SERVICE BULLETIN

EQUIPMENT: IDU-III

BULLETIN NUMBER: WSB IDU-III-4 Revision A

This modification updates the application software to 4.0J.

Figure 1 Completed IDU Limits Programming

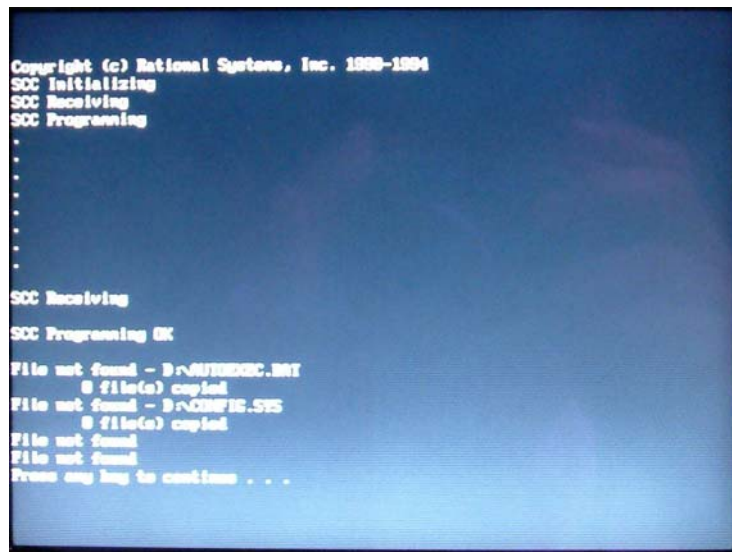
1. If IDUs contain software revision 4.0H, proceed to Step 6.
2. Insert a SmartMedia card in the IDU with the Software Load Module, Limits (P/N 320-145951-0101).
3. Apply power to the IDU and verify the Ground Maintenance menu is displayed.
4. Select item "B" to update the EFIS limits.

5. Follow instructions displayed on screen.
6. Remove power from the IDU after the Ground Maintenance menu is displayed.

NOTE: Updating EFIS software to version 4.0J requires the selection of “Version 2” in the IDU Limits program. It may be necessary to reload the IDU limits for any functions that are available in the in the new EFIS software. Refer to EFIS System Installation Instructions (Doc. 150-045264), Chapter 4 for IDU Limits programming options.
